ADDENDUM NO. 2

WASHINGTON STATE PARKS AND RECREATION COMMISSION
WILLAPA HILLS STATE PARK TRAIL
MENLO TRAILHEAD
NW-C1219

DATE: June 04, 2025

— NW-C1219 WHT-Menlo Trailhead-Drawing Sheet 7 of 15

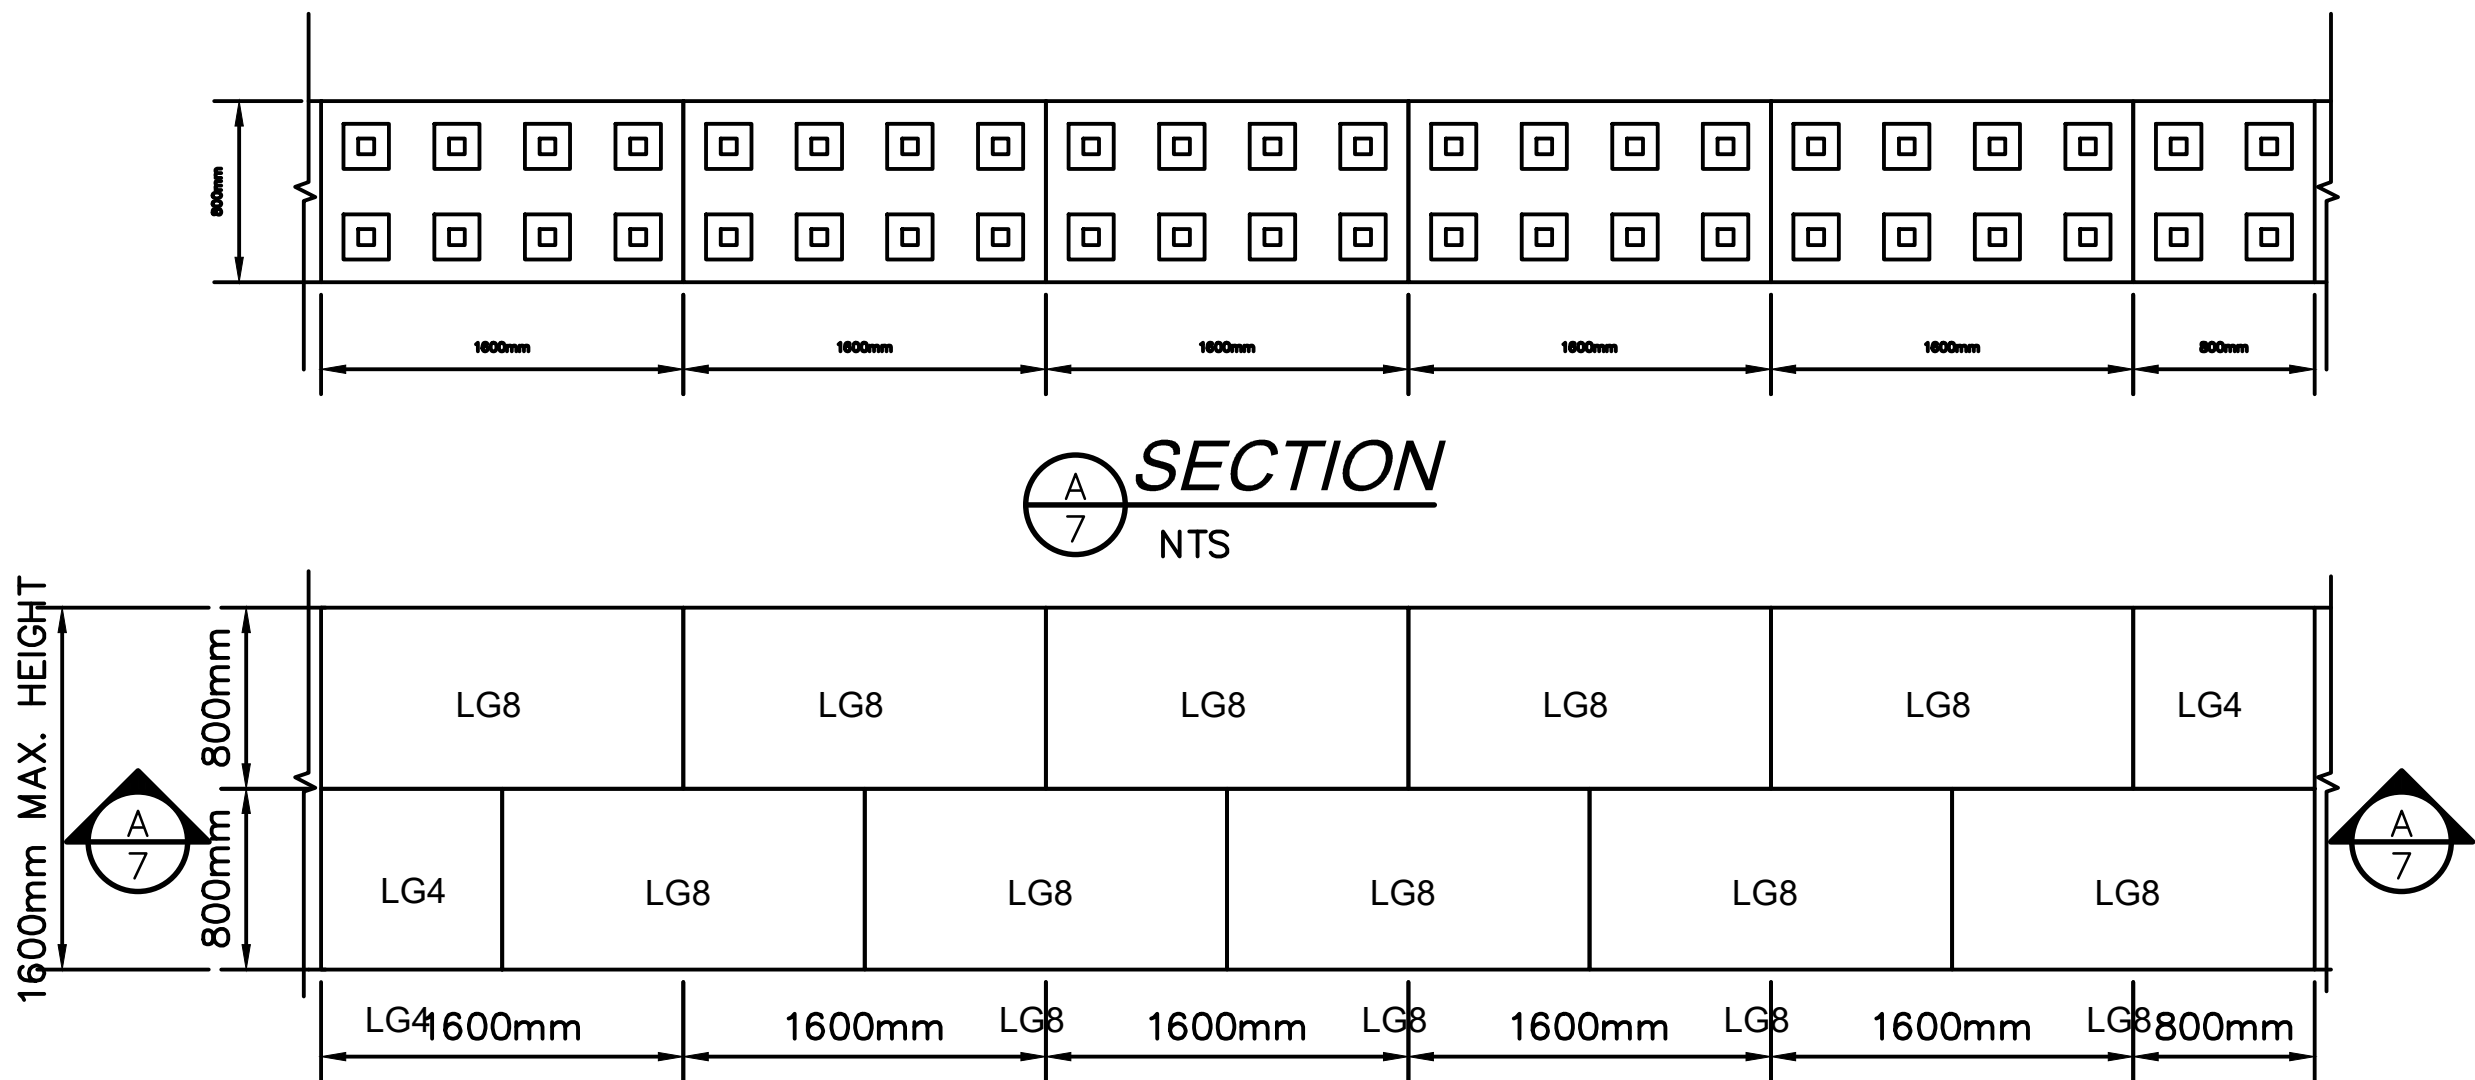
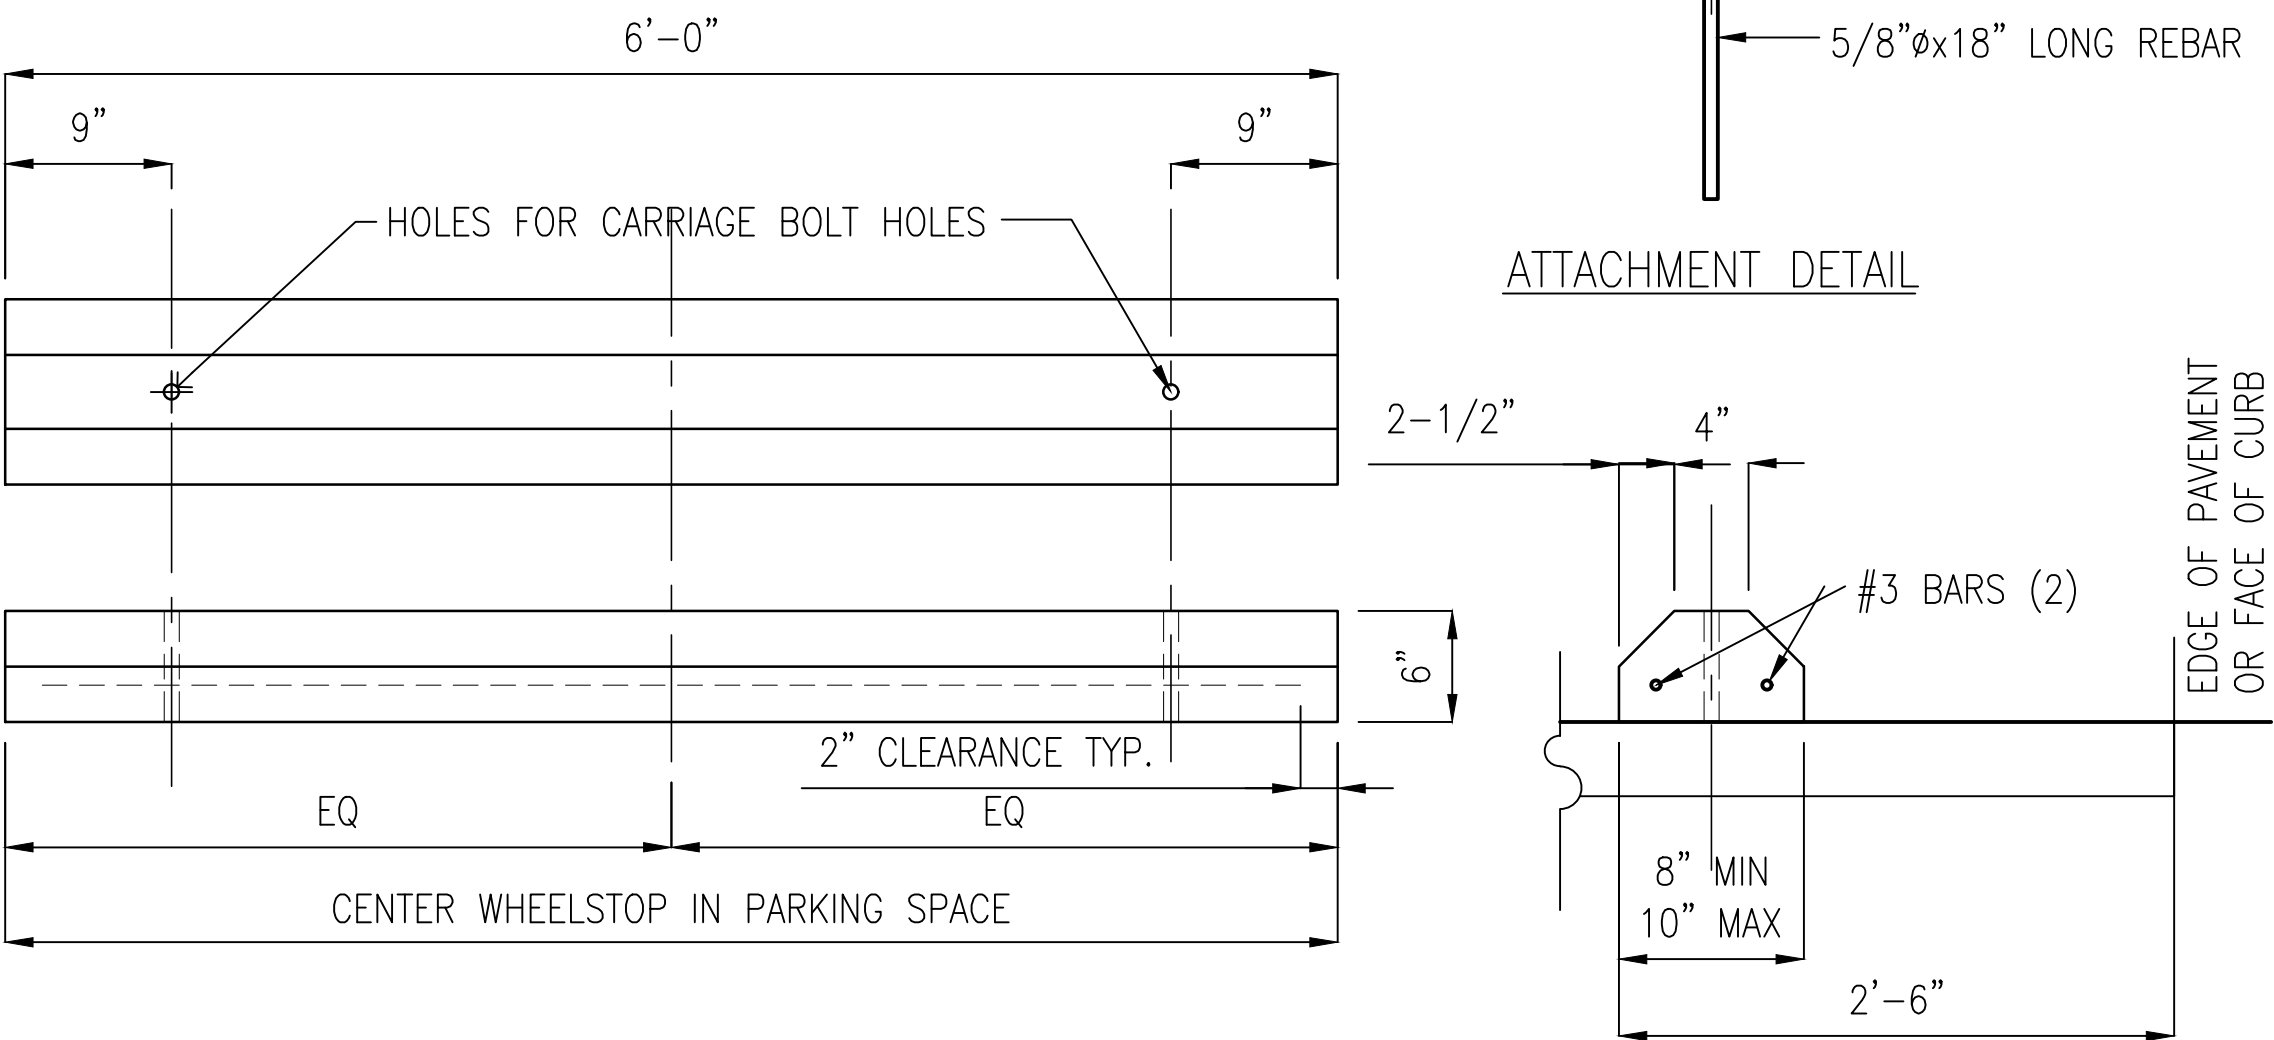
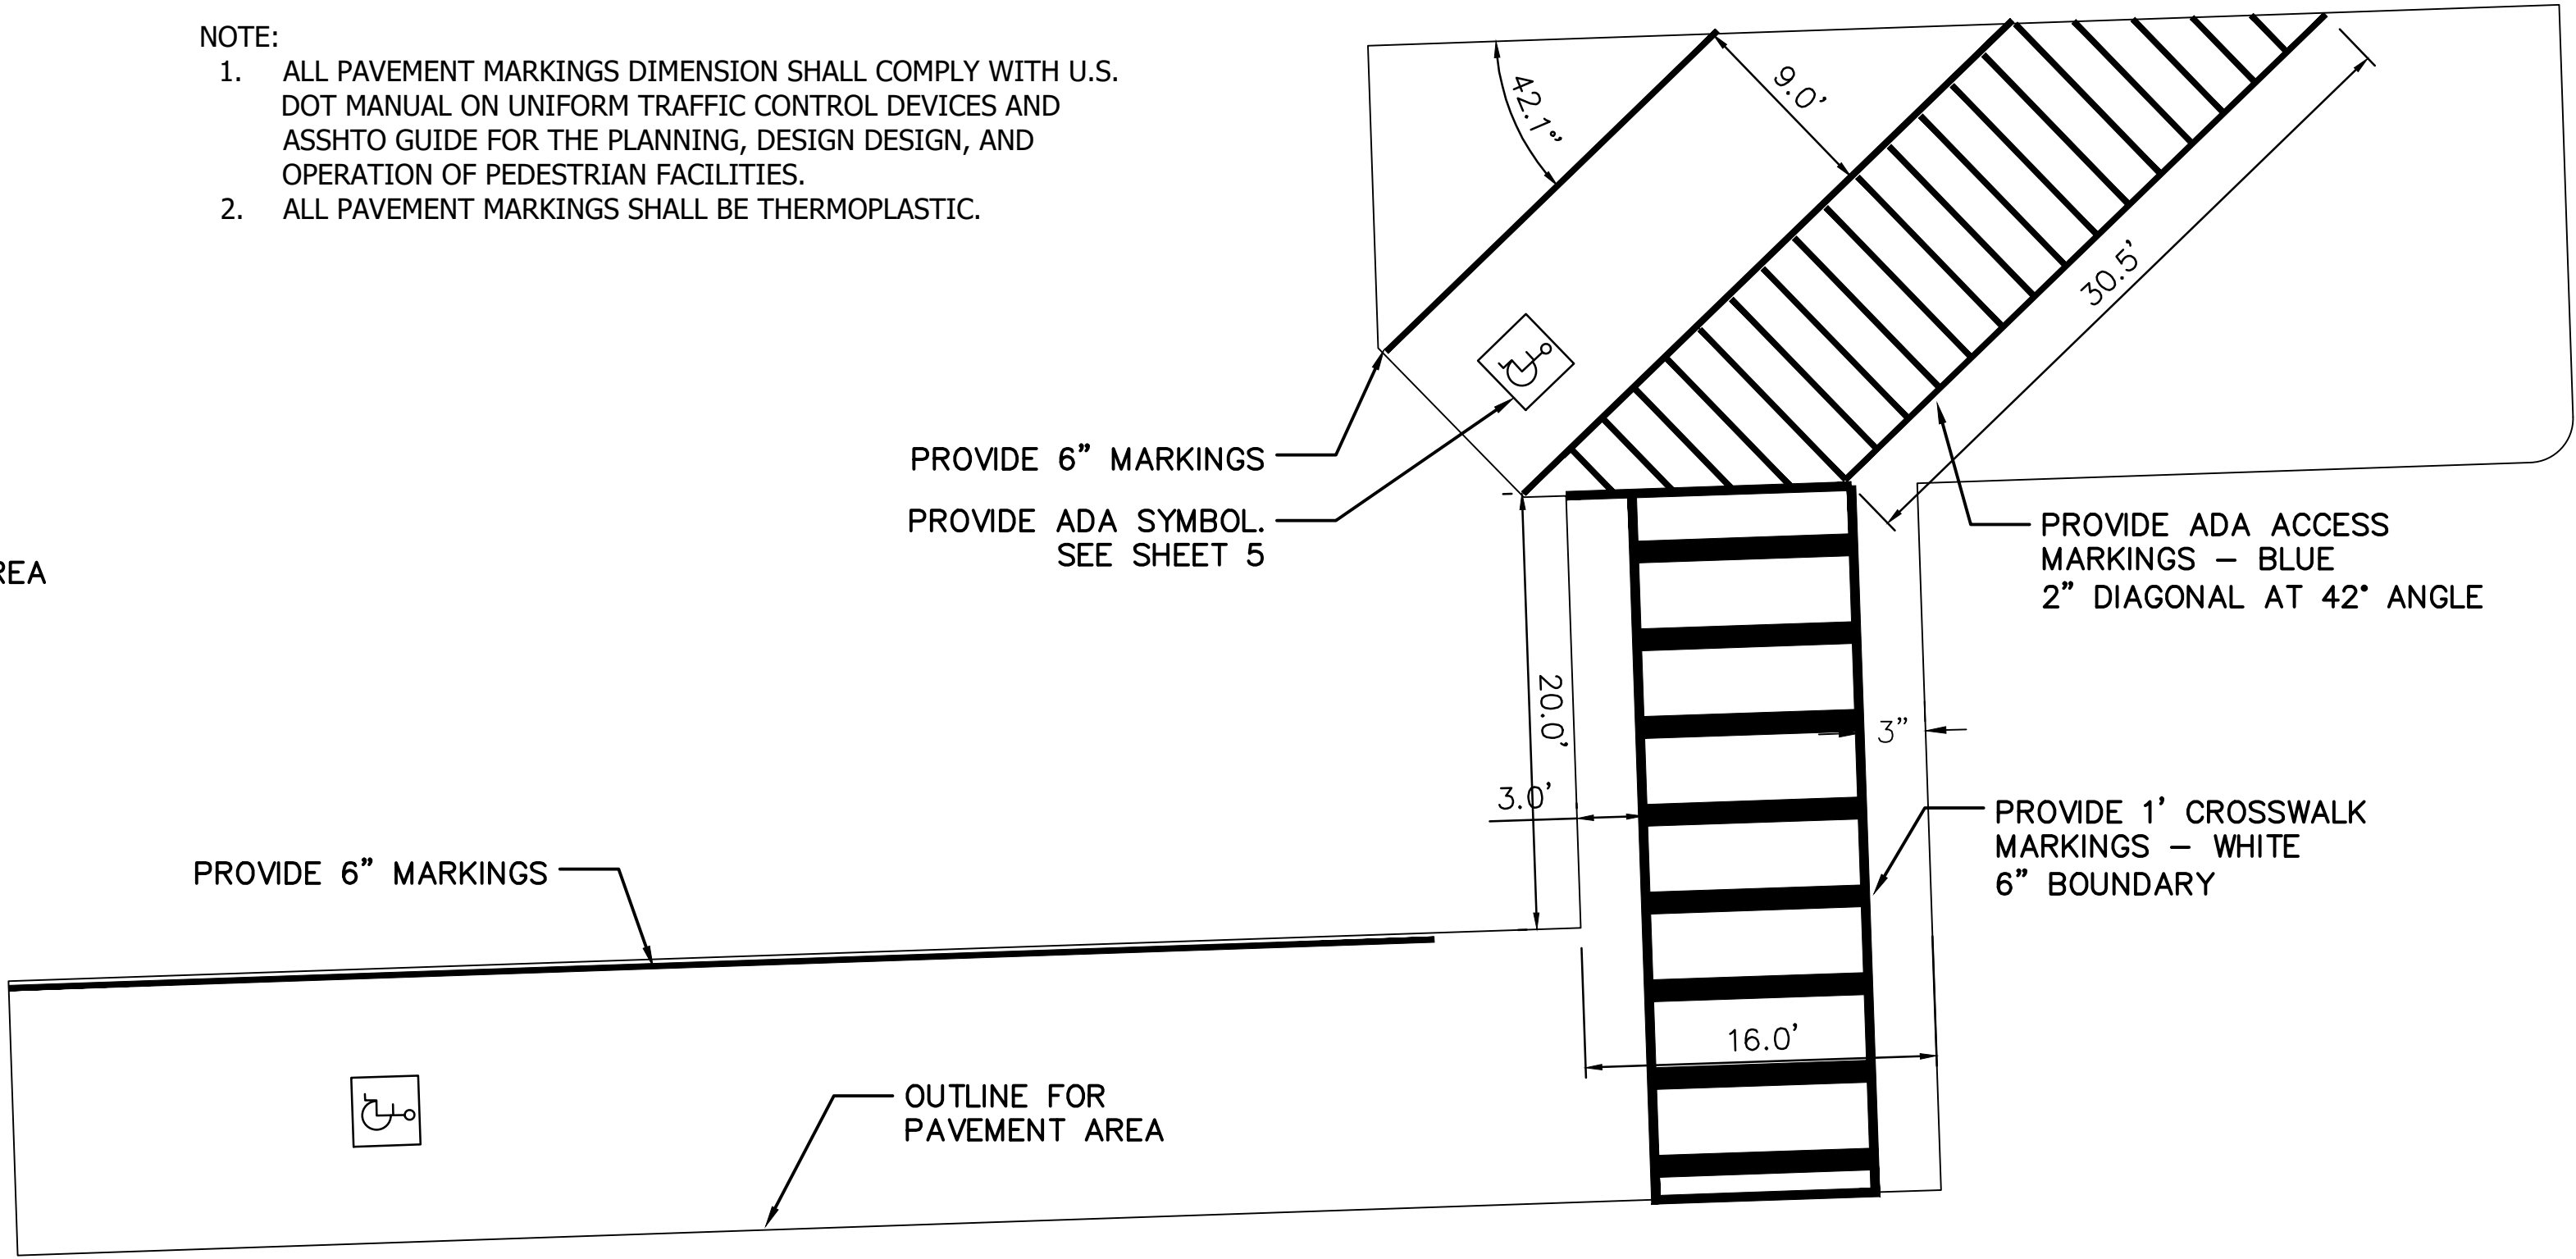
Sheet 7 Revise: RETAINING WALL NOTES:

Line 5: Remove the word "NO" and add: SEE SPECIFICATIONS

Line 6: Remove the word "NO" and add: SEE SPECIFICATIONS

- RETAINING WALLS MUST BE INSTALLED AND CONSTRUCTED ACCORDING TO THE CONTRACT DRAWINGS.
- CONTRACTOR SHALL VERIFY THE ACTUAL LENGTH OF RETAINING WALL ONSITE.
- RETAINING WALL UNITS AND INSTALLATION SHALL CONFORM TO THE ELITE KELLEY BLOCK (LEGATO BLOCK) RETAINING WALL SYSTEMS SPECIFICATIONS GUIDELINES. OR APPROVED EQUAL.
- BACKFILL NATIVE SOIL BEHIND THE RETAINING WALL
- ~~NO~~ GEOGRID IS REQUIRED SEE SPECIFICATIONS
- ~~NO~~ DRAIN PIPE IS REQUIRED BEHIND THE WALL SEE SPECIFICATIONS
